RE: Woodhaven Park Phase II – Access Spacing Design Exception

CITY OF SHEWOOD ENGINEERING DESIGN AND STANDARD DETAILS MANUAL
REQUEST FOR EXCEPTION

ACCESS EXHIBIT
WOODHAVEN PARK PH 2
SHERWOOD, OR

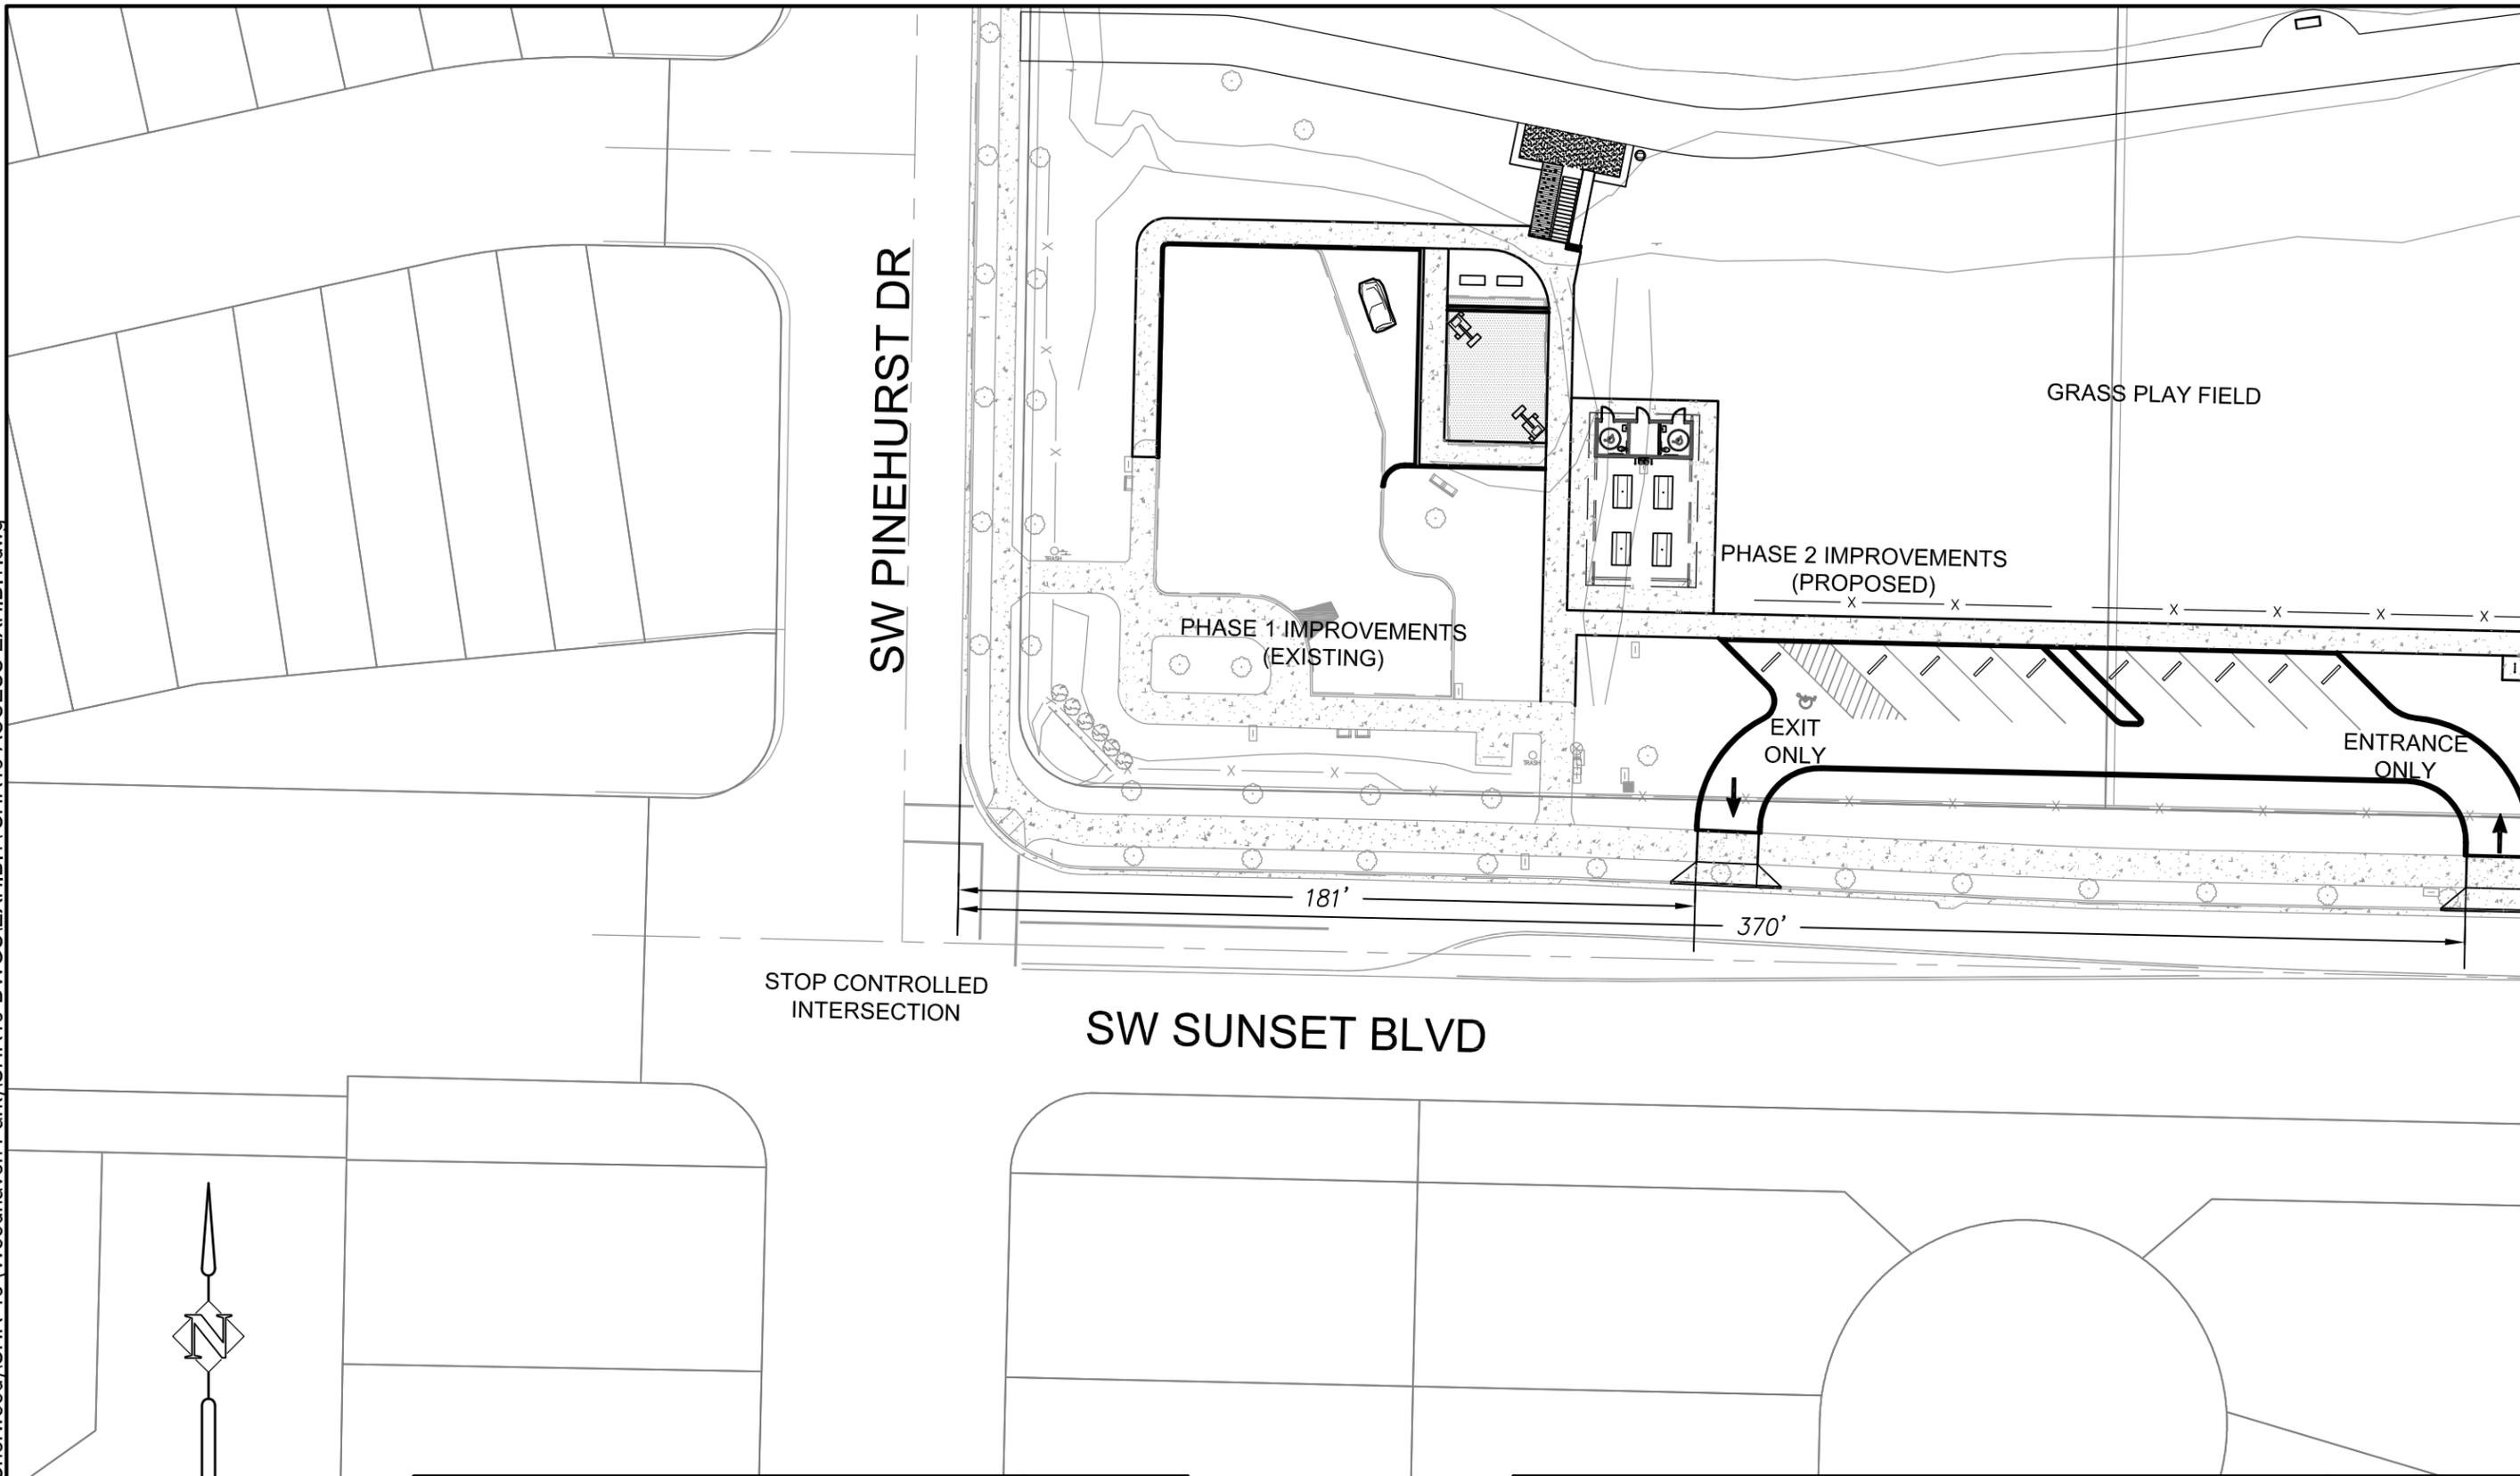
Describe Request: Reduce the minimum distance between face of curb of intersecting street and nearside edge of driveway to 180'.

Design Element	Standard	Proposed
Driveway Corner Clearance	200' (40 mph)	180' (40 mph)
Vehicular Access Management	600'	180'

Reason(s): The layout of the phase 1 improvements to Woodhaven Park were completed in the southwest corner of the park adjacent to the intersection of SW Sunset Boulevard and SW Pinehurst Drive. As part of the phase 2 improvements there is a desire to have the new parking lot located adjacent to the phase 1 playground improvements to encourage use of the parking and limit the distance to the playground. The parking lot is planned to be a one-way parking lot with the driveway located 180' from the intersection being exit only and the entry driveway being 370' from the intersection.

The Engineering Design and Standard Details Manual Section 210.8 covers the recommended corner clearance distances for driveways. SW Sunset Boulevard designated an arterial and the design speed is 40 mph (35 mph posted) which corresponds to a minimum corner clearance distance of 200'. The driveway is located 180' from the intersection to match the existing layout of the site including proximity to play area and minimizing disturbance of the grass play field. The 180' distance corresponds to the minimum corner clearance for a 35 mph design speed. This

reduction is justified because the intersection of SW Sunset Boulevard and SW Pinehurst Drive is stop controlled, so vehicle speeds are reduced.

The Municipal Code Section 16.106.040 M covers vehicular access management spacing. Per the code, the recommended spacing of driveways from an intersection on a minor arterial is 600'. This is a recommended spacing for access control along an arterial corridor. SW Sunset Boulevard, while designated as an arterial, operates more like a collector. The stop controlled condition at SW Pinehurst Drive is one example of how SW Sunset Boulevard operates like a collector. Since the 600' spacing does not fit the context of the corridor and the project has demonstrated an acceptable driveway spacing to meet the Engineering Design Manual, we request a design exception to this standard.
